**BOARD OF APPEALS, CITY & COUNTY OF SAN FRANCISCO**

Appeal No. **26-042**

The substance or effect of the decision or order appealed from is the ISSUANCE on July 23, 2026 to Jinghui Wu, of an Alteration Permit (Revision to Permit No. 202603127448: new deck at rear (8 x 20ft) and minor layout changes) at 2463 Alemany Blvd.

**Appeal of Building Permit No. 202607145029**

(P) REAR ELEVATION

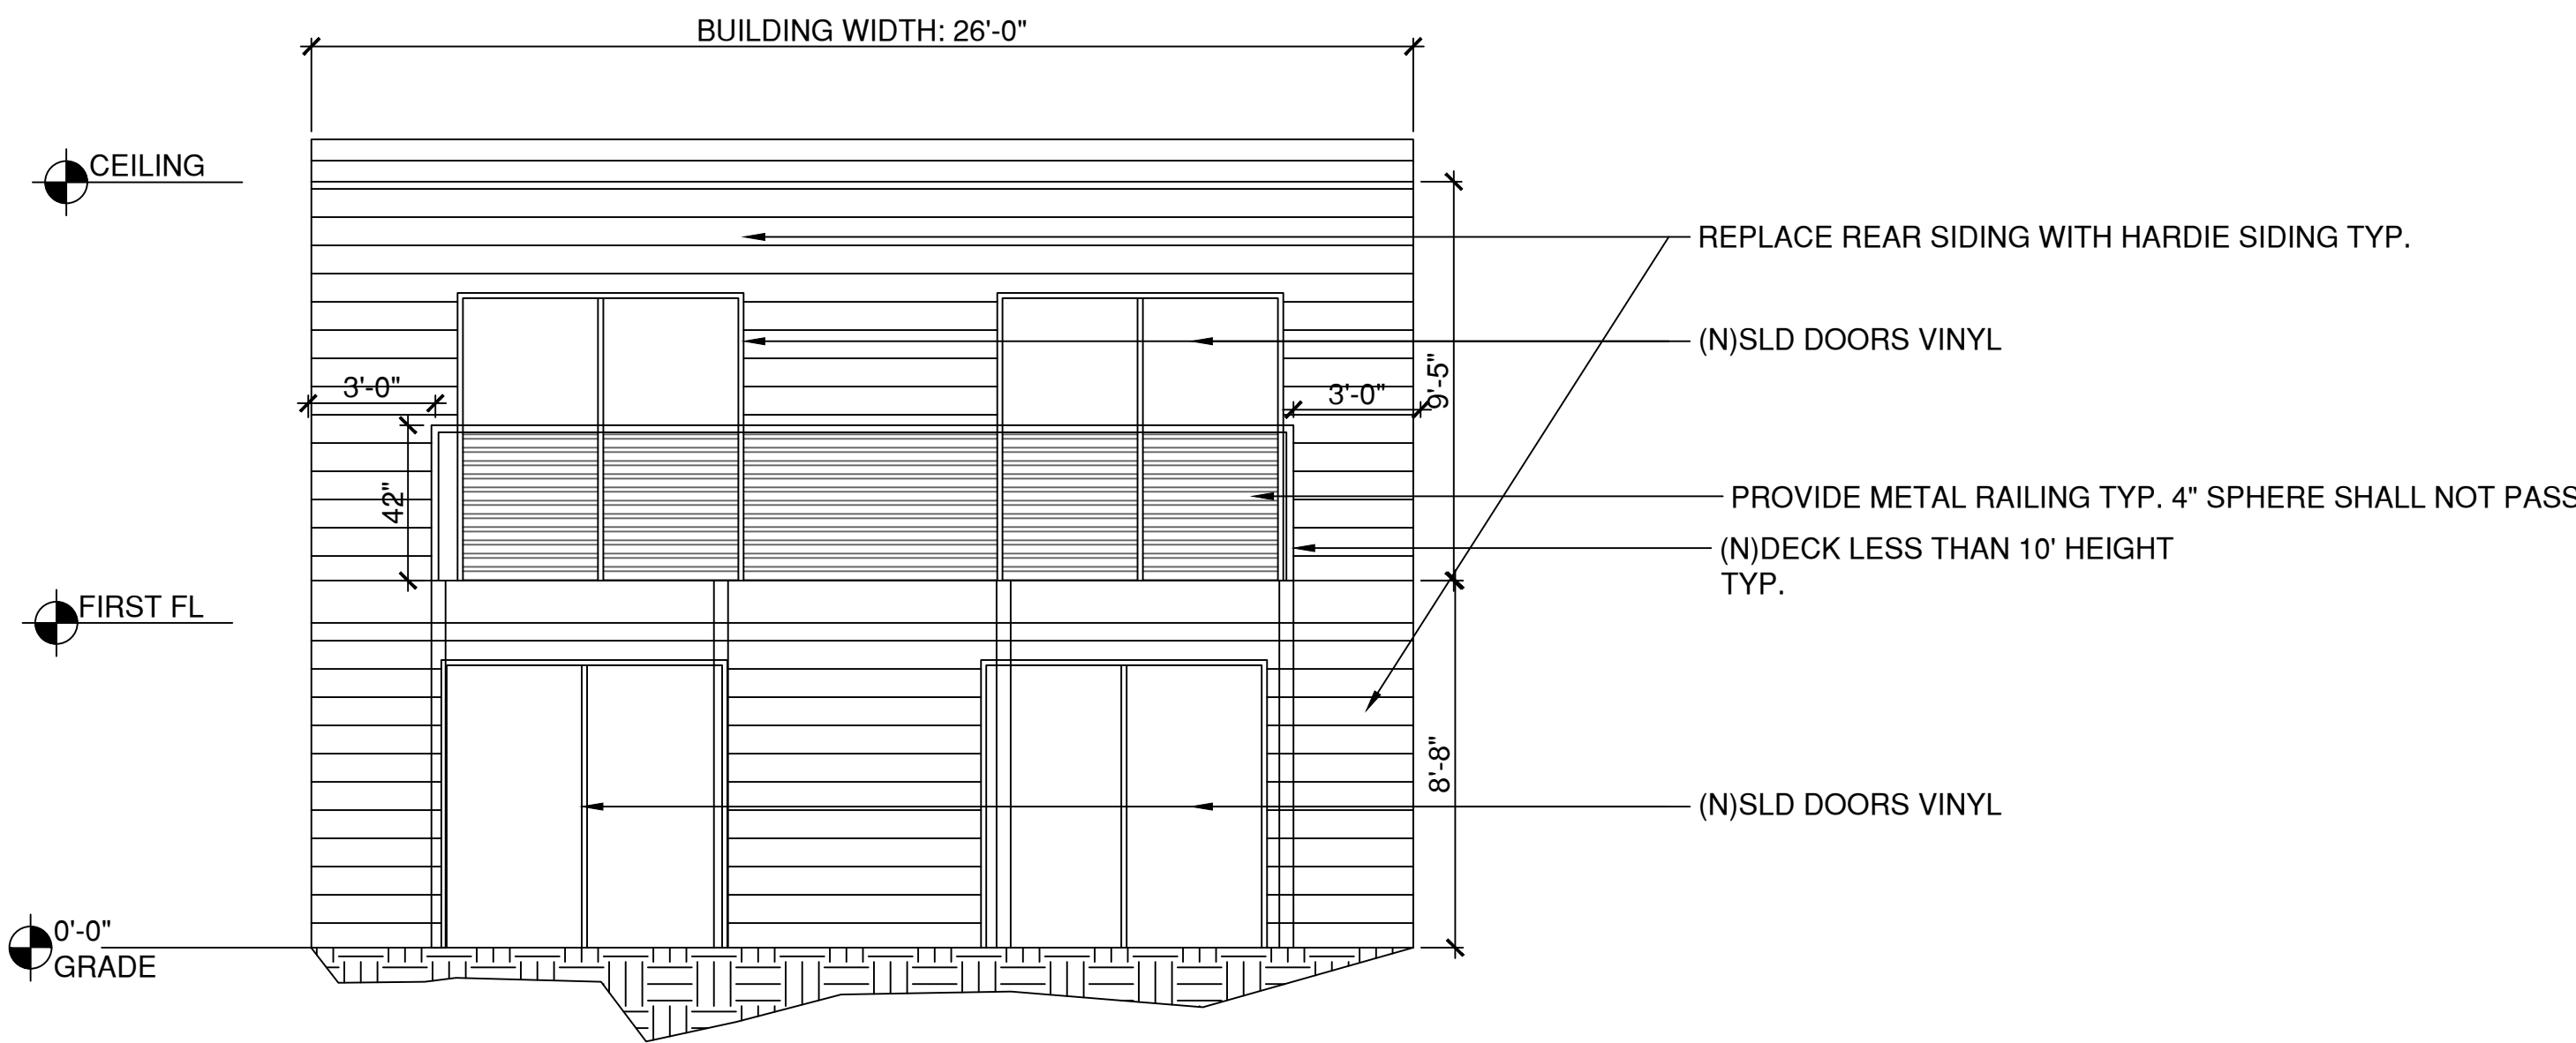
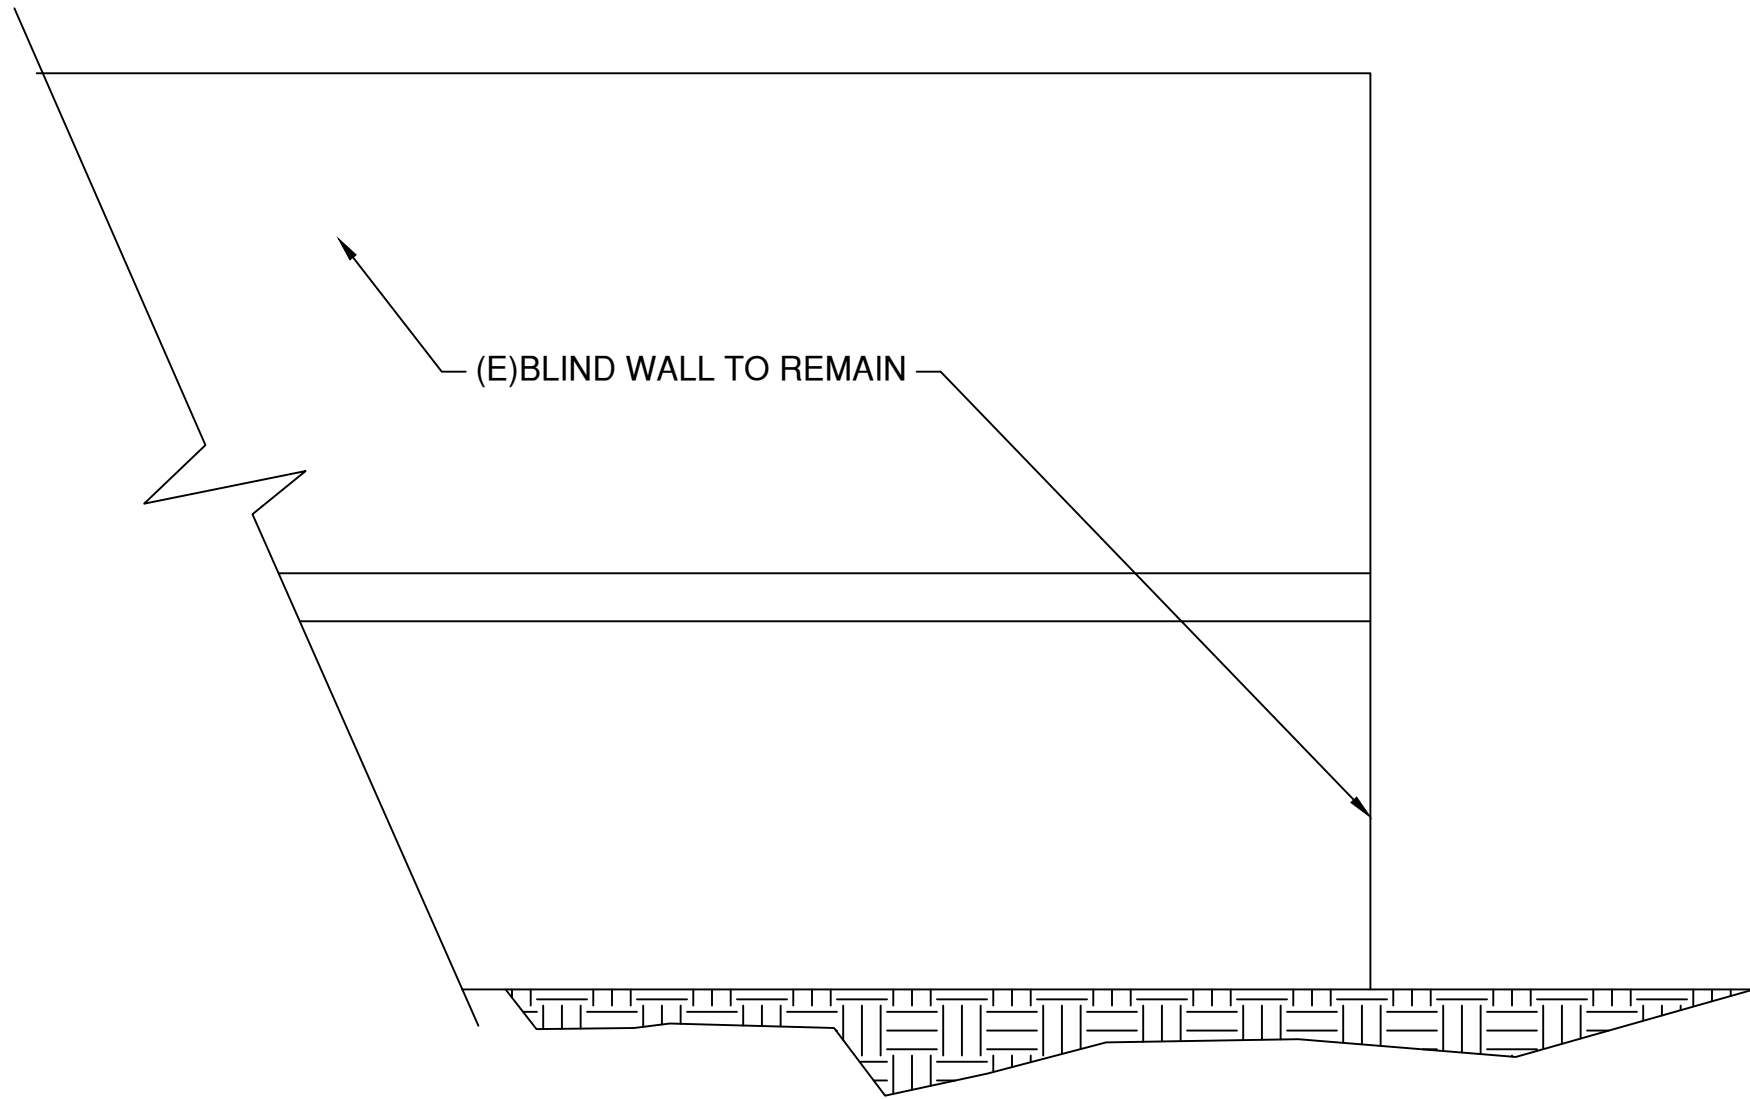
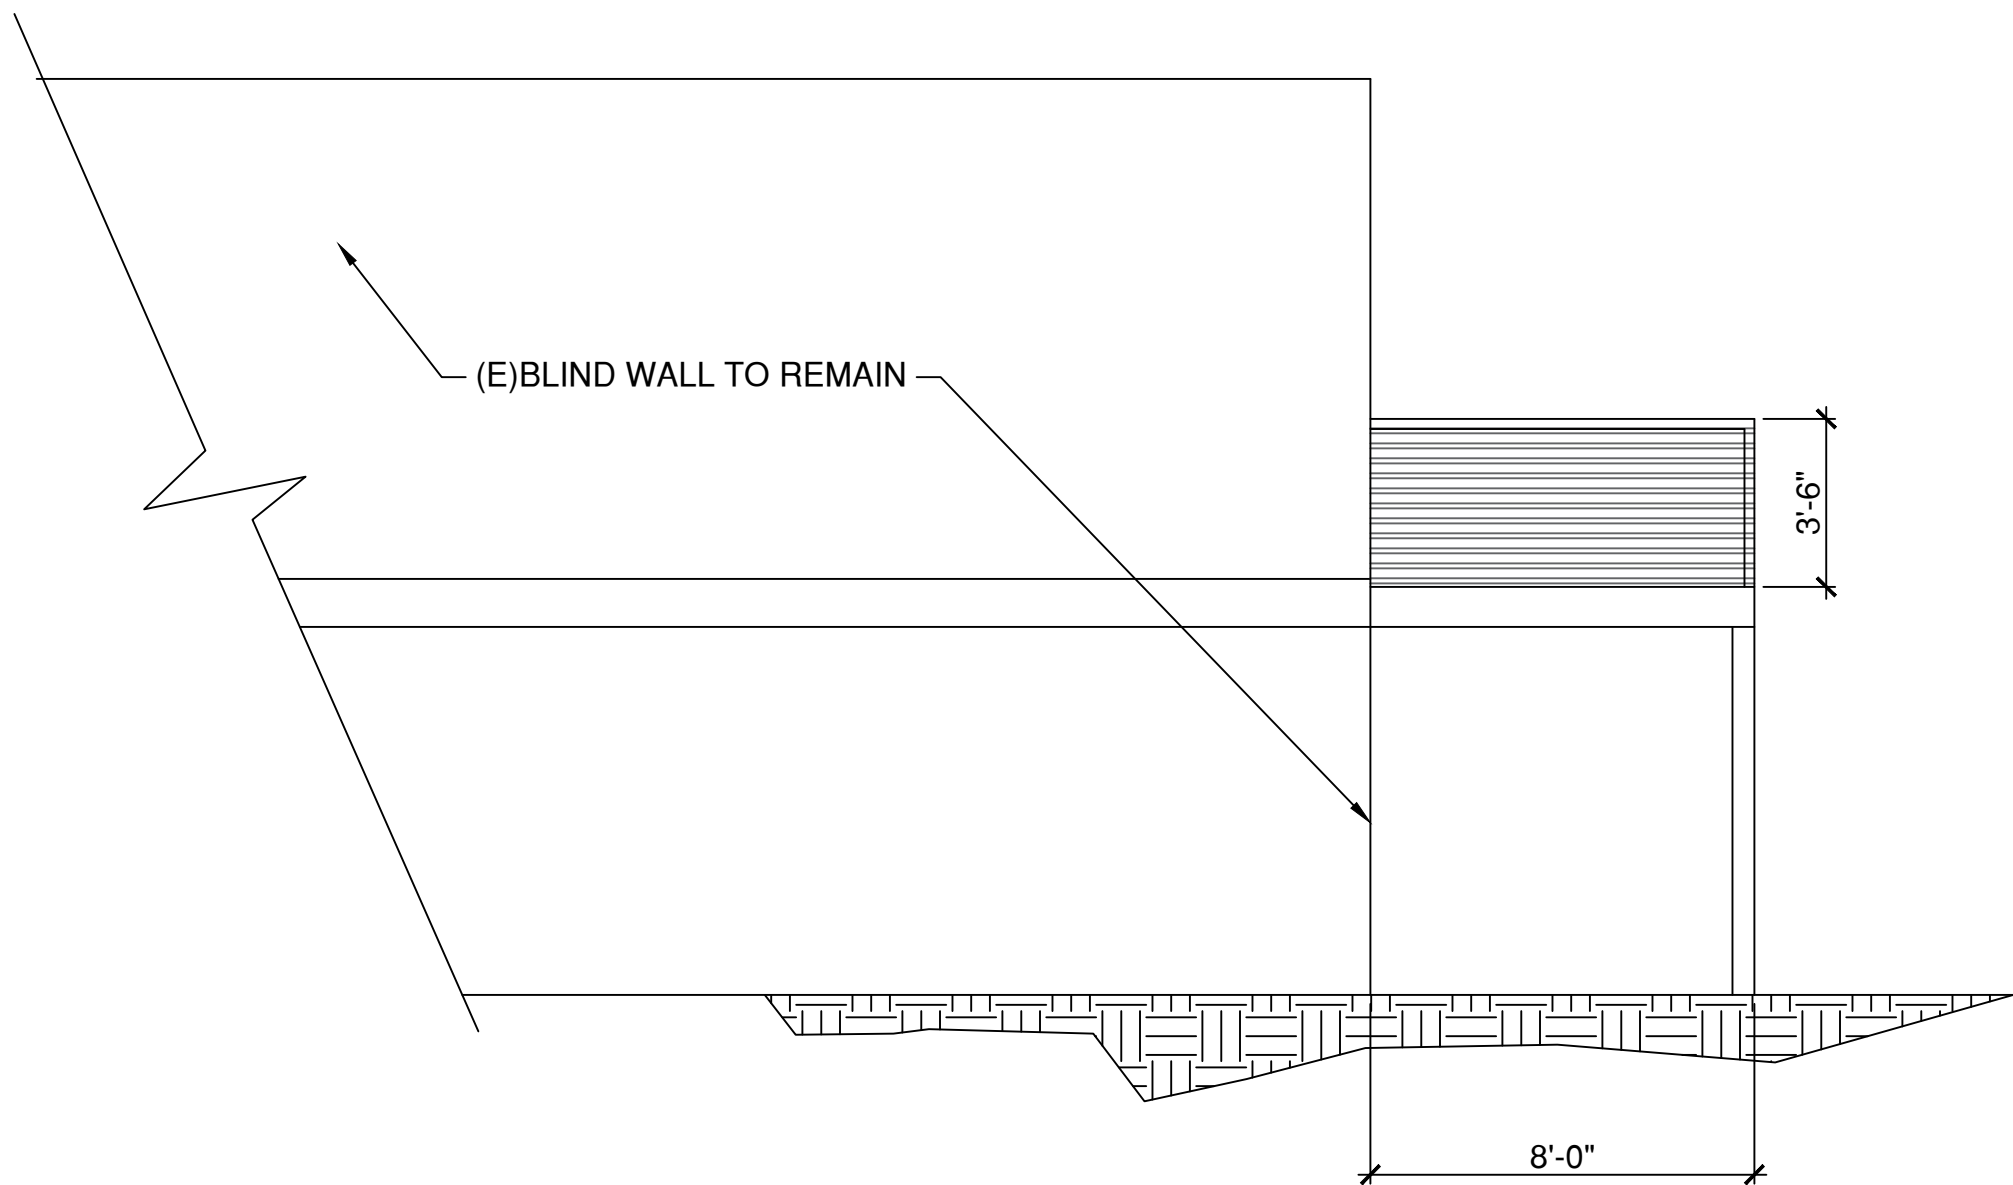
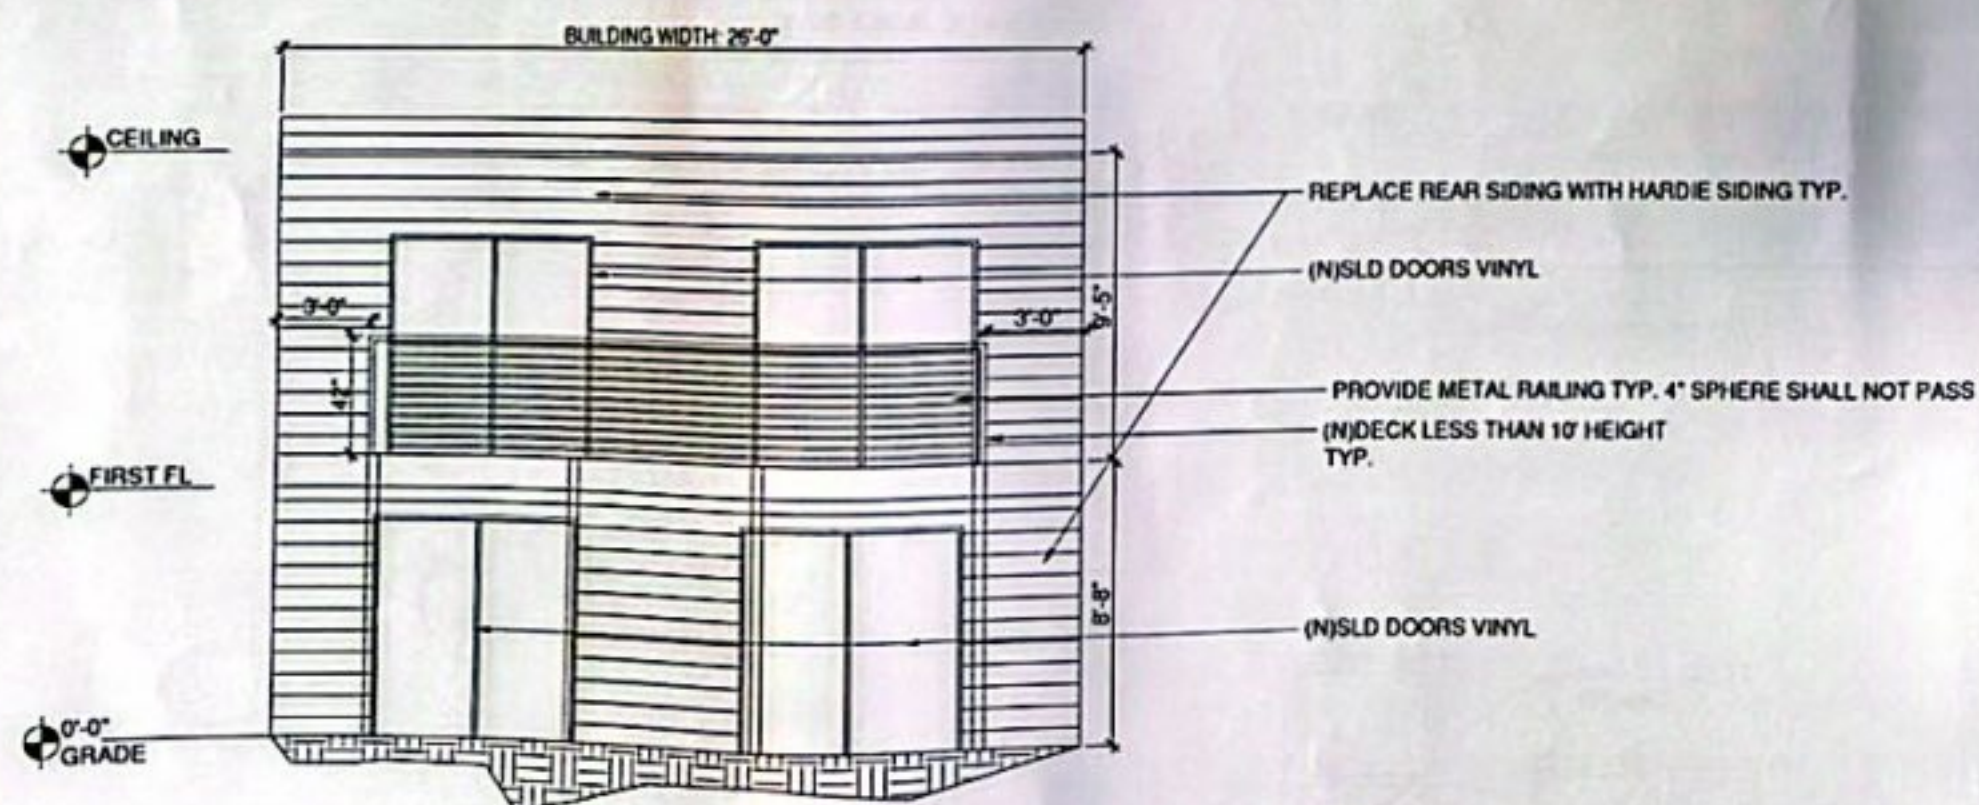
**1. Privacy Impacts** - Due to the height and placement of the proposed deck, occupants on the structure will have a direct line of sight into our primary bedroom, located at the rear of our home. The proposed deck would materially diminish our ability to enjoy our bedroom and the rear portion of our property without exposure to views from the neighboring deck.

**4. Neighborhood Aesthetic Impacts** - The proposed deck, measuring approximately 160 square feet, would be the largest rear-protruding structure on our block. Its size and elevation are inconsistent with the existing pattern of development and will negatively affect the visual character of the neighborhood. The structure will be prominently visible from multiple adjoining properties and will alter the established aesthetic of the rear yards along the block.

Red line is about 6 feet in between appellant's primary bedroom window and proposed deck

The Permit Holder respectfully requests that the Board deny the appeal and uphold Building Permit No. 202607145029 without modification. The permit authorizes a modest, approximately 8-foot-by-20-foot rear deck serving a single-family home. The deck is outside the Planning Code's required rear-yard area, does not exceed nine feet in projection, has a walking surface less than ten feet above grade, is set back three feet from the shared property line, and uses an open guardrail and open post-supported construction.

The Permit is consistent with the Planning Code and Residential Design Guidelines. While the Appellant raises concerns about privacy, the proposal does not create any unique or substantial privacy issues beyond what is expected for development within the City. More specifically, it follows the guidance provided by the Planning Department’s “Residential Decks” handout by providing the 3-foot setbacks at each side.
